Re: Palmeraie Phase II -City of Scottsdale Comment Response Letter
Re: 7-ZN-2016#2
Key Code: 95T74
CVL Project No.: 1.01.0268924

The following is a summary and response to the comments provided as a part of the 1st review for the above referenced project:

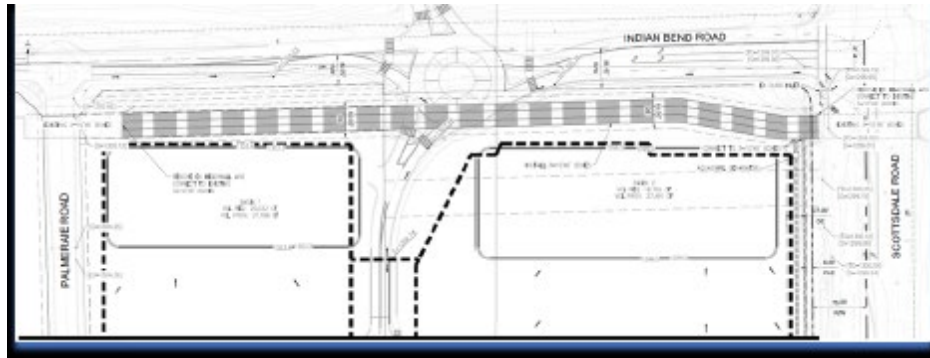
- h. The Engineer must show/call out the locations, size, and invert elevations of all storm drain pipes and box culverts in sections A-A & B-B as appropriate. The

Engineer must also show the limits of the proposed D.E. in sections A-A & B-B as appropriate. The rule of establishing the limits of the proposed D.E. over a storm drain pipe or over a box culvert was explained to the Engineer in a meeting and this rule must be verified and followed when dedicating the proposed D.E. over a storm drain pipe or over a box culvert. It should be noted that more cross-sections maybe requested by the reviewer during the Improvement Plans review. (DSPM, Sec. 4-1A)

Response: SD profiles have been included in this submittal as a part of the preliminary drainage report. Limits of required drainage easements have been provided on preliminary grading plans.
